ADDENDUM

Date Issued:	Feb. 16, 2023
Project:	IHC Health Services, Inc. (Intermountain Health) Facility Design and Construction (FD&C) 36 South State Street, 16th Floor Salt Lake City, Utah 84111-1486
Addendum Number:	2

Intermountain Healthcare
 Utah Valley Regional Medical Center
 MRI Replacement

A113

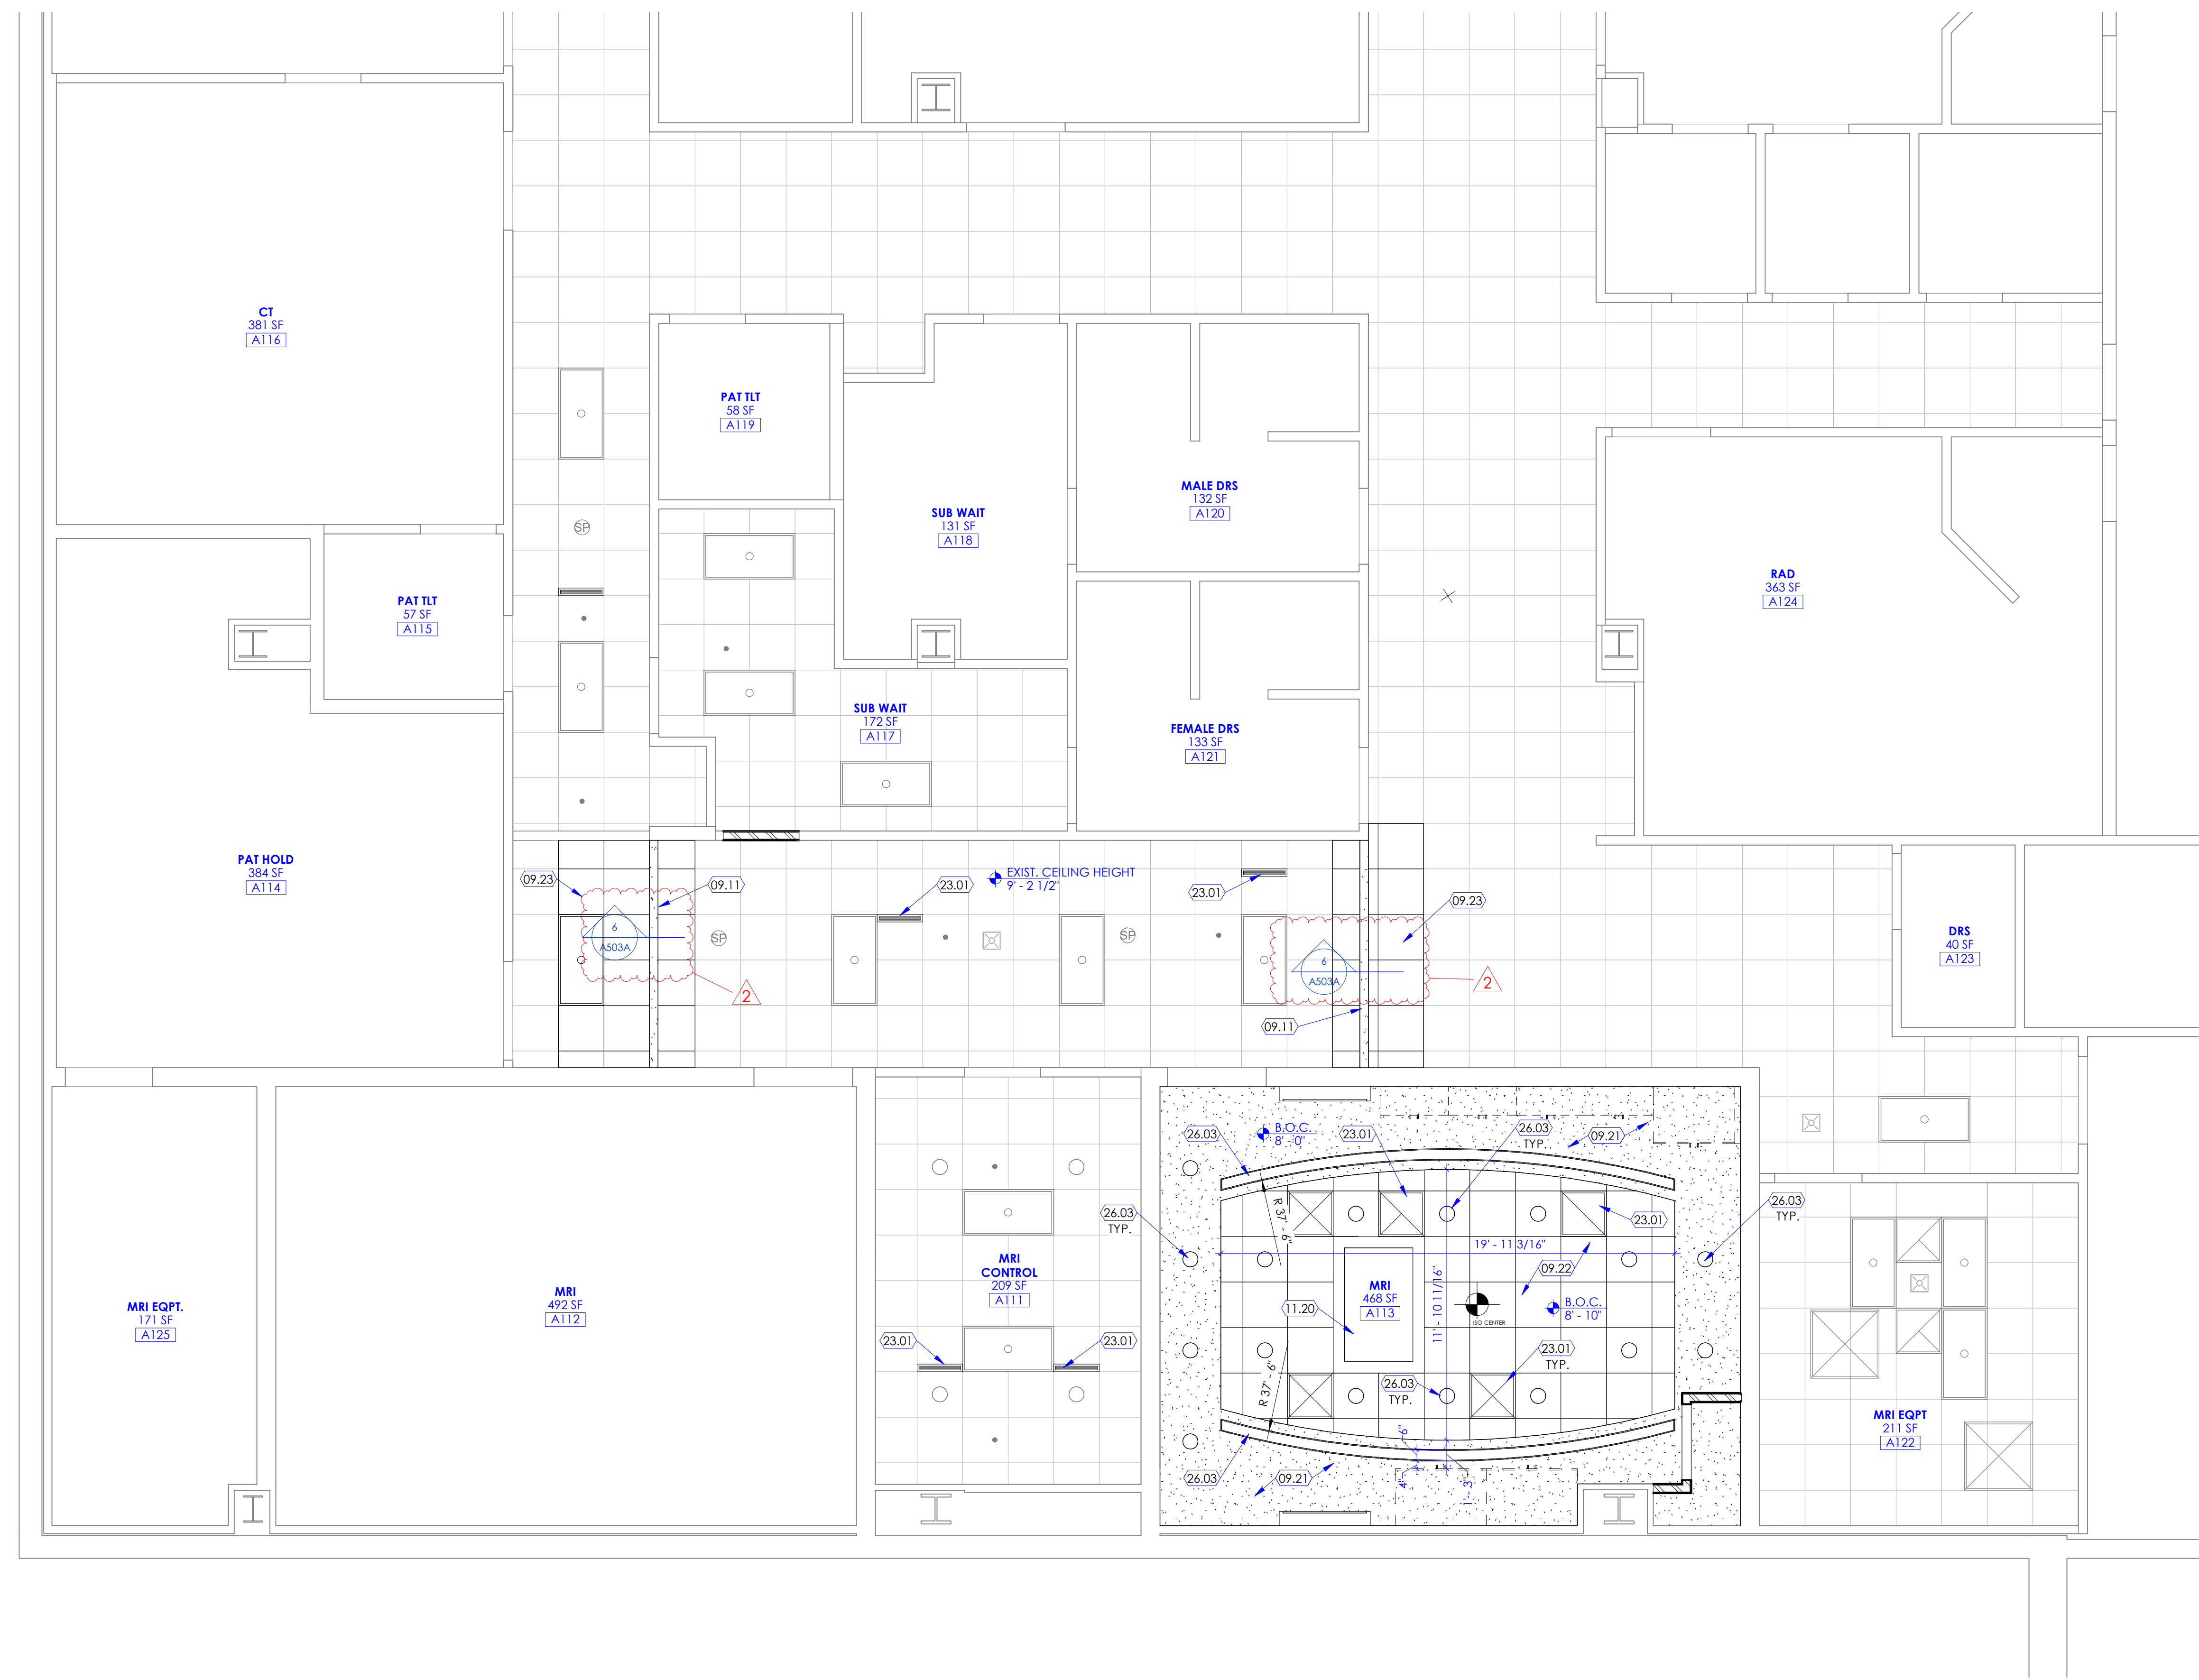
Item Number	General Items Description
1	Extend bid deadline to Monday, February 20, 2023 at 5:00 PM.
Sheet Number	Drawings
Architectural Drawings	
A113	Add keynotes 08.26, 08.24.
A116	Add section call out 6/A503A as indicated.
A117	Add interior elevation call out 3/A251 as indicated.
A251	Add interior elevation 3/A251, note package height and widths. Add keynotes 08.24, 08.26.
A601A	Revise comments as indicated. Revise door schedule as indicated.
Electrical Drawings	
EP101	Add power for auto-doors.
Specification Section	Project Manual
Architectural Sections	
08 42 29 23	Specification Sheet for Dura-Glide 3000 sliding door.

- 08.24 ALUMINUM-FRAMED STOREFRONT SYSTEM, WINDOW SYSTEM SHALL BE 2' X 4 1/2" TYPE FRAMES, GLAZING SHALL BE LOCATED CENTERED IN THE FRAME. FRAMES SHALL BE CLEAR ANODIZED.

- 08.26 AUTOMATIC SLIDING ALUMINUM AND GLASS DOOR ENTRANCE WITH BREAKOUT FUNCTIONALITY, STANLEY DURAGLIDE 3000 SERIES AS BASIS OF DESIGN.
- 09.02 PATCH AND REPAIR WALL FINISHES, BUMPER GUARDS, WALL BASE, ETC. TO MATCH ADJACENT/UT.

EP101

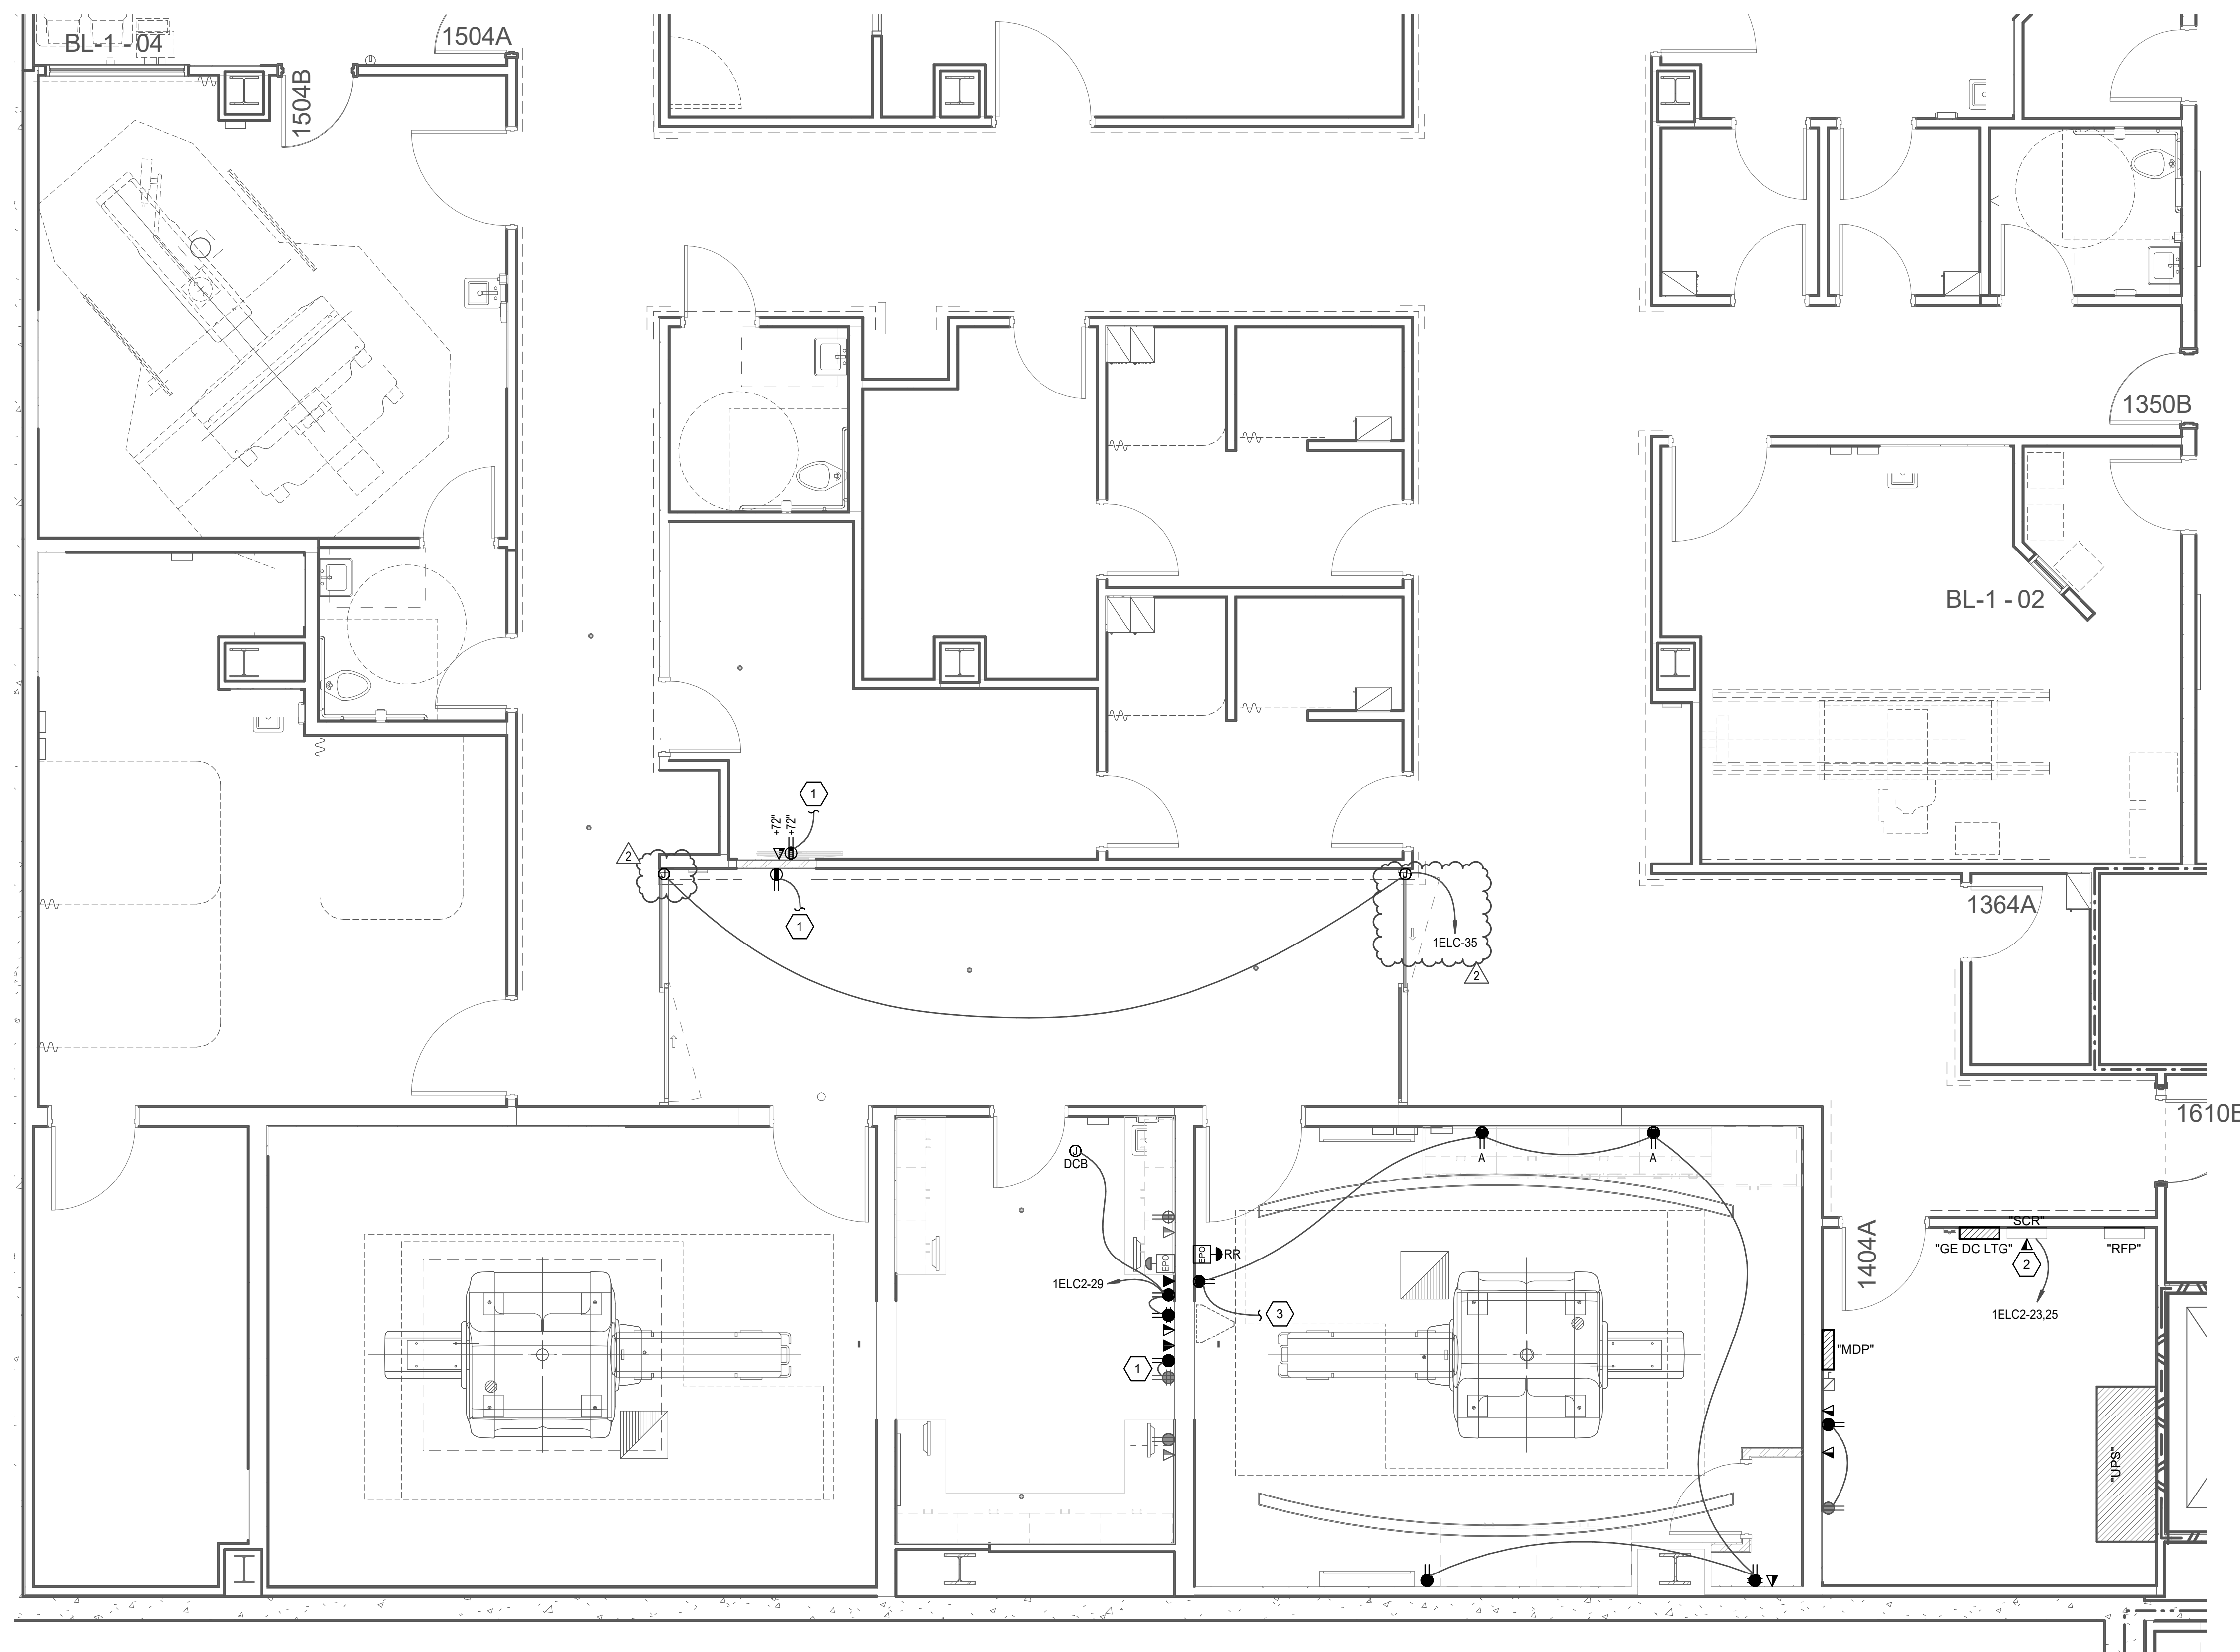
1. EP101 – Level 1 Power Plan
 - a. Added power for auto-doors.
